Product History and
Service Notes

Firmware History for HP DesignJets 750C and 755CM (Model A)

Air Flow from the Fan can Cause Spray and Misdirection

Figure 1

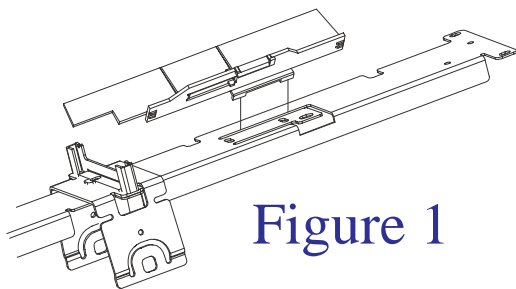
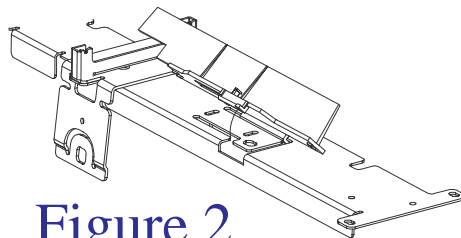
Air flow from the fan can cause spray and misdirection, generating a vertical band in certain prints on glossy media.

A new part has been designed to be installed in the Y-yoke. The Y-yoke is the metallic part mounted on the chassis between the two slider rods.

- 3 Identify the cuts in the Y-yoke where the fan deflector is to be installed. These cuts are on the left side of the plotter.
- 4 Passing the fan deflector between the slider rods and the encoder strip, install the two front clips in the cut as shown in figures 1 and 2.
